"Opposition to 402 E. Broughton Street and Request for Improvements"

STATEMENT OF JIM HUNDSRUCKER OPPOSING THE COA FOR 402 E. BROUGHTON STREET

COMMENT OF ANDREW JONES IN OPPOSITION TO THE COA FOR 402 E. BROUGHTON STREET

COMMENT OF ANNA HABERSHAM WRIGHT IN OPPOSITION TO THE COA FOR 402 E. BROUGHTON STREET

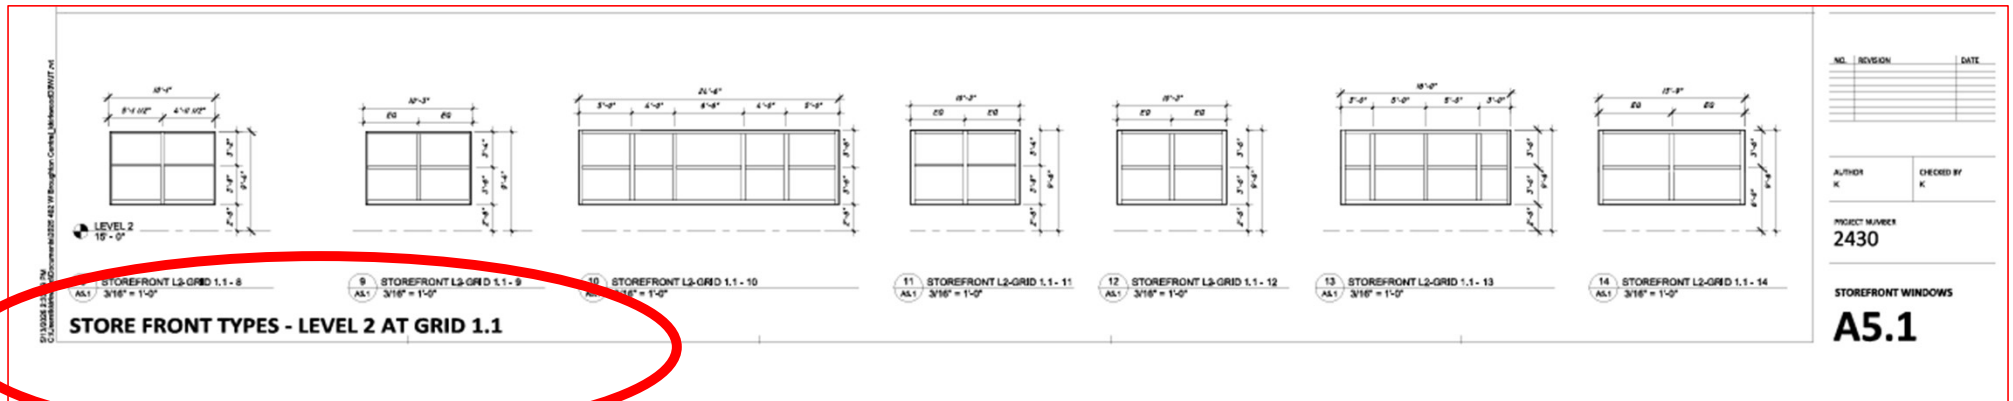
7.8.10(h)(i)(2)(a)(ix) “The distance between windows shall not be less than for adjacent contributing buildings.”

PROPOSAL FAILS THE WINDOW PROPORTION REQUIREMENT

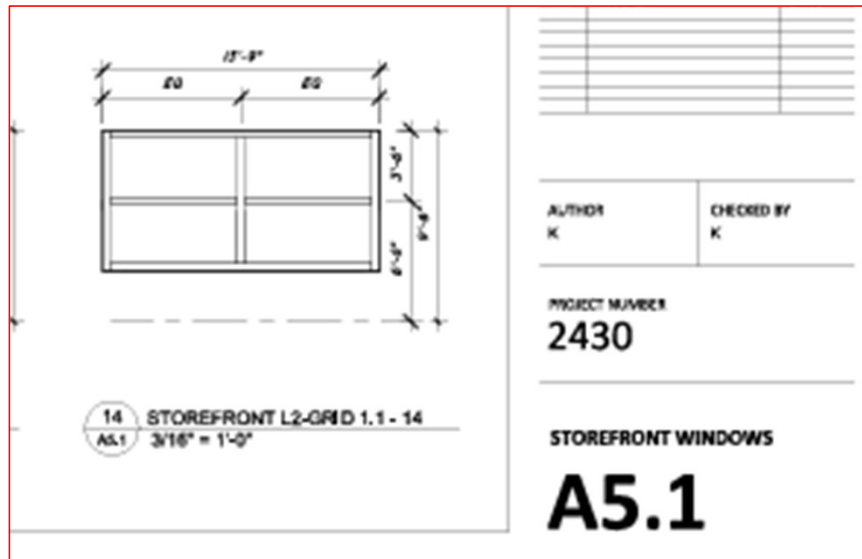
Section 7.8.10(h)(i)(2)(a)(i) states, “All windows facing a street, exclusive of storefronts, basement and top story windows, shall be rectangular and shall have a vertical to horizontal ratio of no less than 5:3...”

Neither the entire window nor each half is vertically proportioned.

New Version

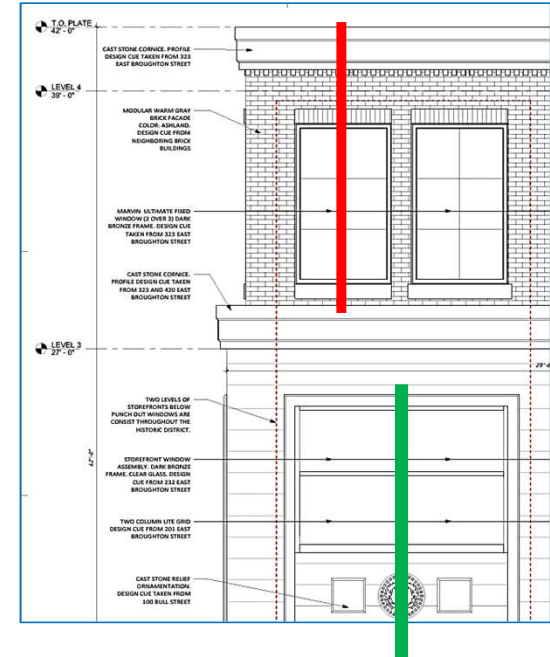
Third Floor Windows are pairs of separate window **openings**, each surrounded with masonry. Red line is the centerline of each window **opening**.

Second Floor Windows are located in horizontal window **openings**. Green line is the centerline of the window **opening**.

7.8.10(h)(i)(2)(a)(iv) **Centerline Rule.** “The centerline of the window and door **openings** all align vertically.”

The centerline of the window **openings** on the third floor do not align vertically with those below.

PROPOSAL FAILS THE BUILDING FORM RULE

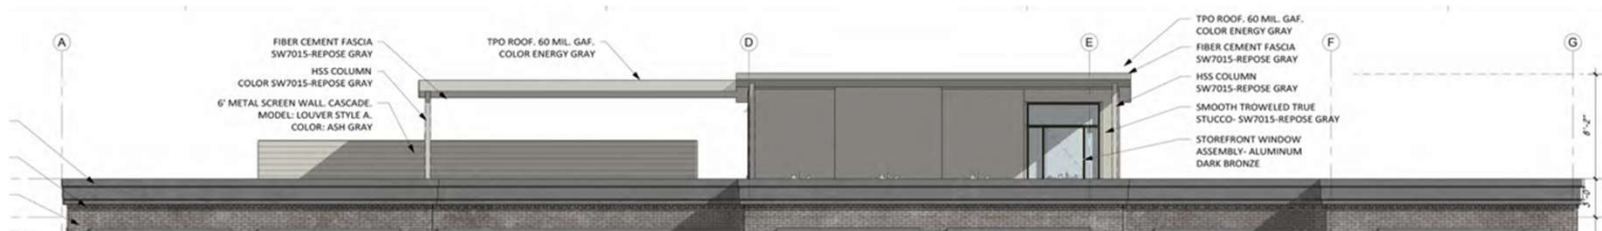
There is no evidence in the COA application of a flying canopy roof on any qualifying building.

13.5 Building Form: “The physical shape of a building resulting from its mass, height, and envelope.”
